Agenda
Village of Arlington Heights
Design Commission
Community Room, 3rd Floor

Arlington Heights Village Hall
33 S. Arlington Heights Road
Arlington Heights, IL 60005
June 12, 2018
6:30 PM

A. DC#18-025 - Arlington Downs Apartment Building -
3400 W. Euclid Ave. - Multi-Family New

A. DC#18-048 - European Crystal Hotel - 519 W. Algonquin Rd.
- Commercial

2 NORTH ELEVATION @ GARAGE - DC
SCALE: 1/8" = 1'-0"

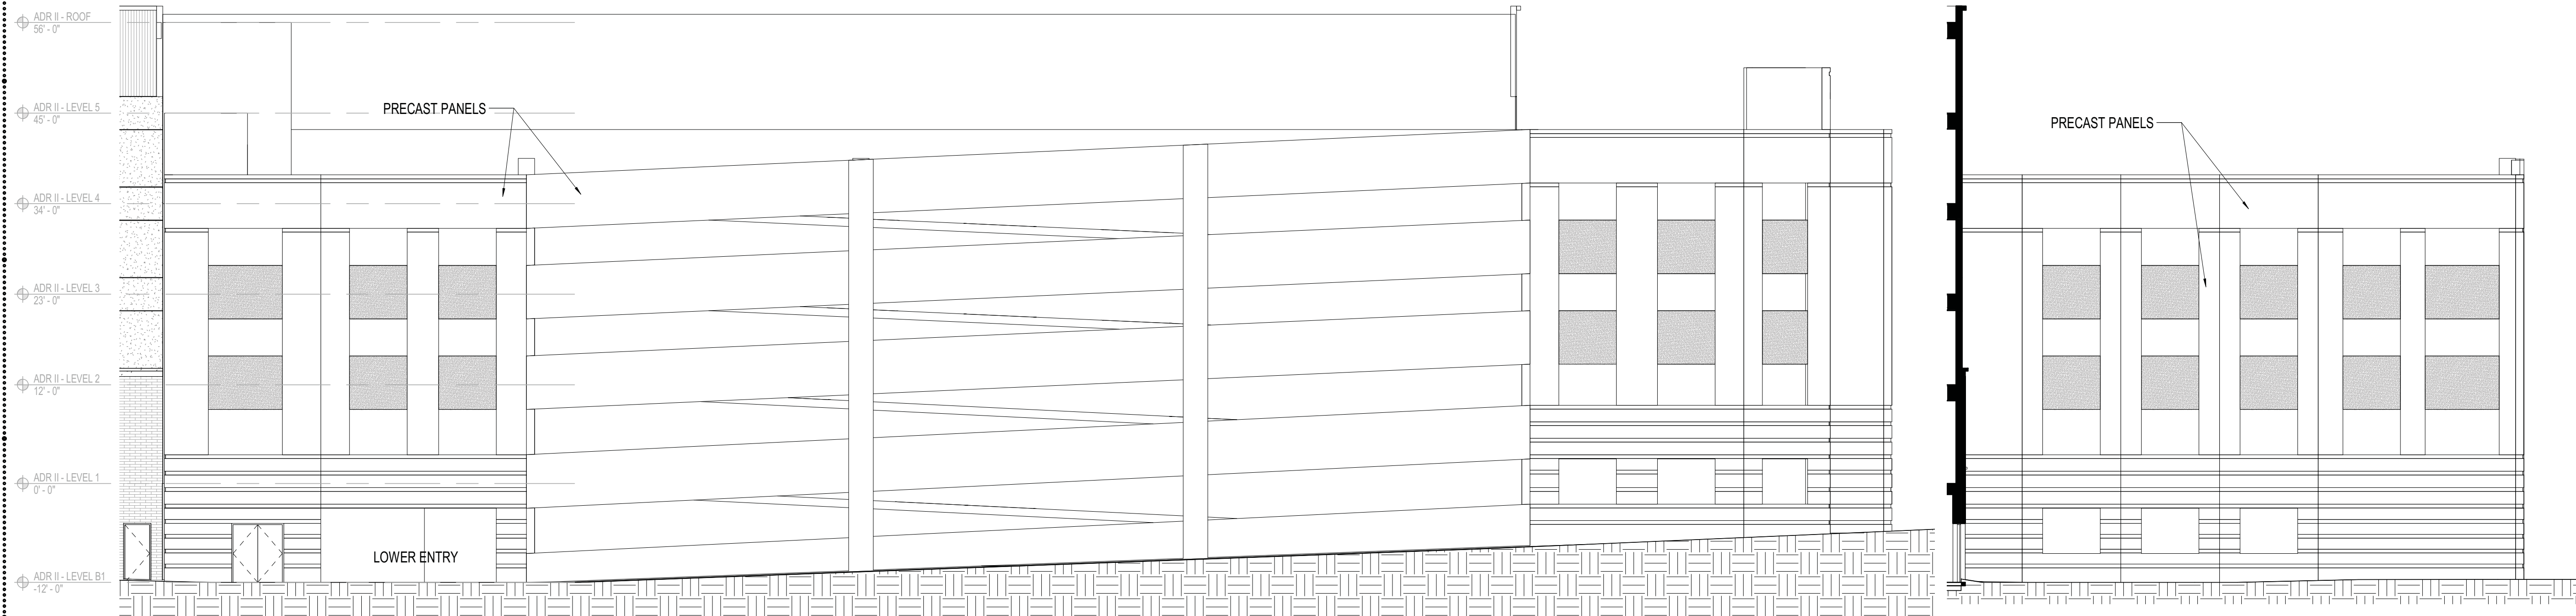
4. It is recommended that the metal mesh screens in the garage stair tower be replaced with a glass curtain.
5. It is recommended that color be added to the base of the garage to complement the apartment building.

6. It is recommended that the cornice detail be added back to the precast concrete garage walls.
7. Clarify the exterior wall material, finishes, and colors of the apartment building walls abutting, and above, the top floor of the garage. These walls need to be of a finished quality consistent with the apartment building design.

- The precast concrete garage panels are still too monochromatic. It is recommended that color be added to the base of the garage to complement the apartment building.

- The previous plans included a small cornice detail at the top of the garage, which has been omitted. It is recommended that the cornice detail be added back to the design.

ENTRY CANOPY

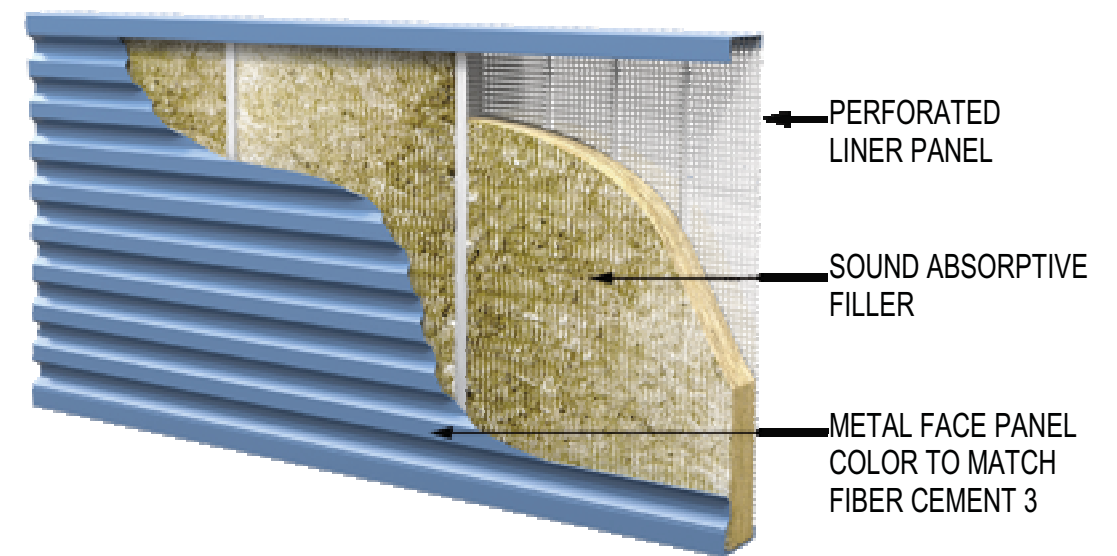
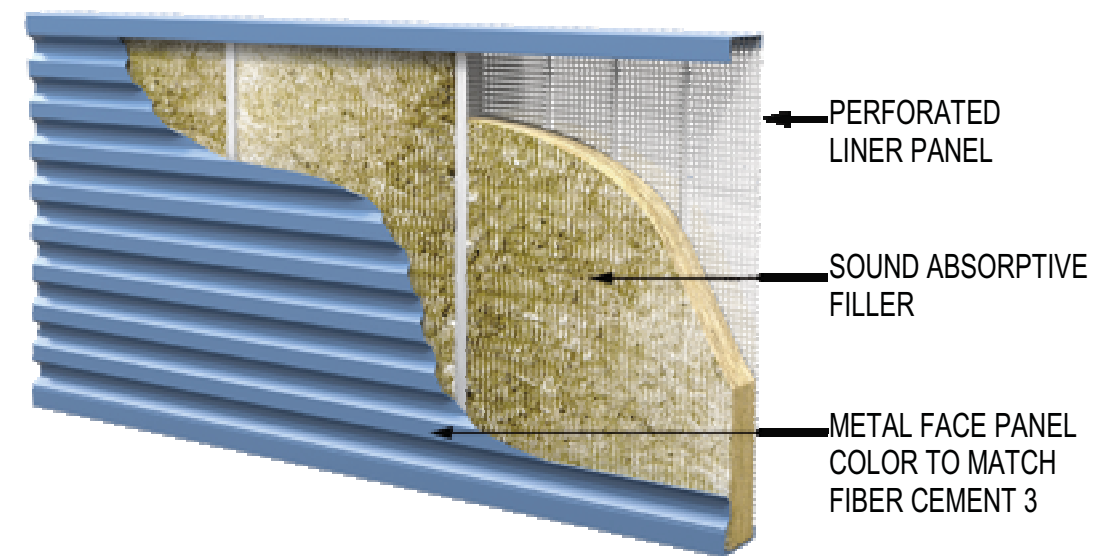
- The entrance canopy has been widened, raised, and angled support columns added to complement the entrance canopy design at the existing 'One Arlington' building.

- The revised entrance canopy is much improved from the previous design, and it works well to signify the entrance.
- The proposed metal mesh screen wall at the garage is a creative solution to visually separate the garage from the apartment building, and it works well to add interest to the sloped portion of the east wall. Options to grow vegetation on the east screen wall are encouraged.

2 PROPOSED NORTH (FRONT) ELEVATION
SCALE : 3/32" = 1'-0" MAY 4, 2018

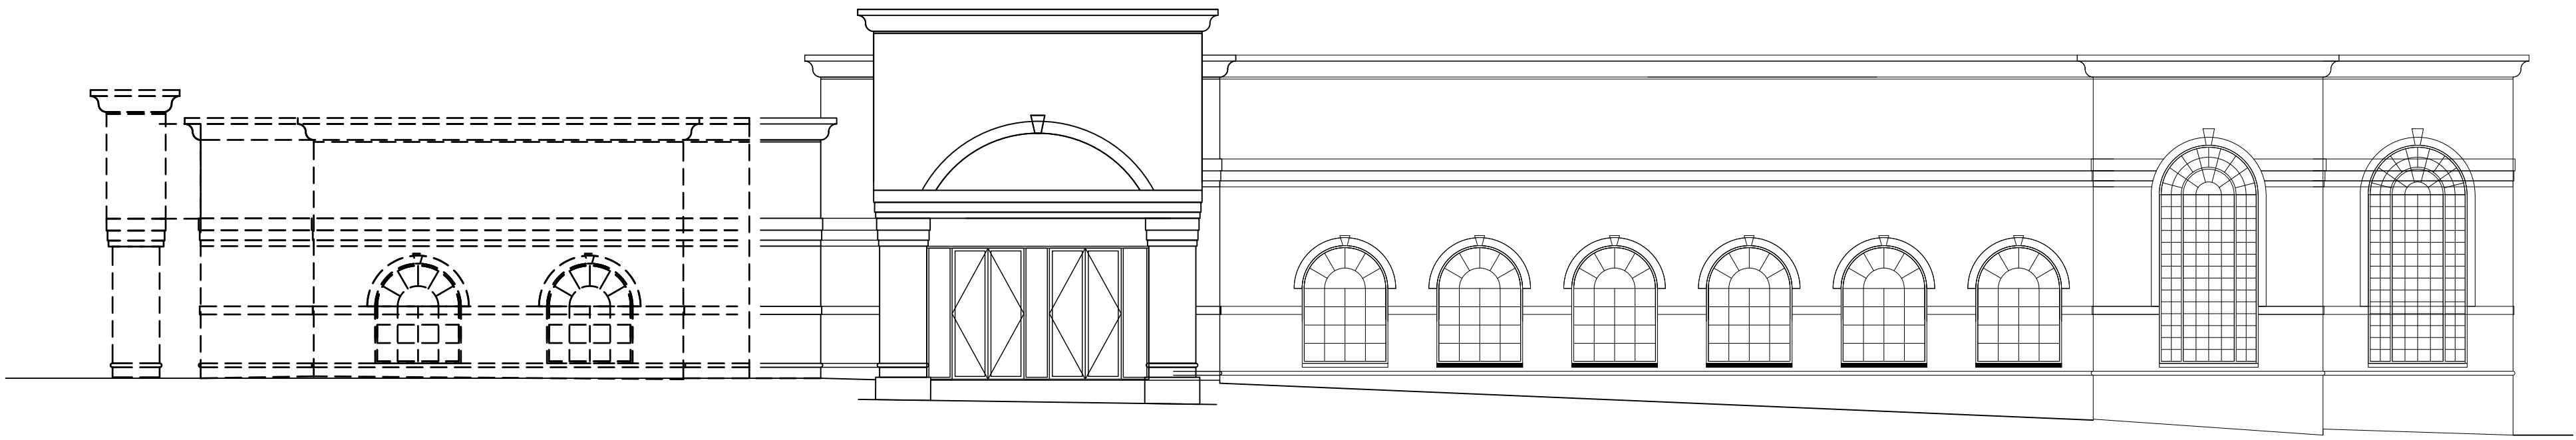
1. Adjust the spacing of the transom at the first floor windows to match the same size as the transoms in the second floor windows above
2. All signage shall meet code, Chapter 30, and separate sign permits are required.
3. This review deals with architectural design only and should not be construed to be an approval of, or to have any other impact on, any other zoning and/or land use issues or decisions that stem from zoning, building, signage or any other reviews. In addition to the normal technical review, permit drawings will be reviewed for consistency with the Design Commission and any other Commission or Board approval conditions. It is the architect/homeowner/builder's responsibility to comply with the Design Commission approval and ensure that building permit plans comply with all zoning code, building permit and signage requirements.
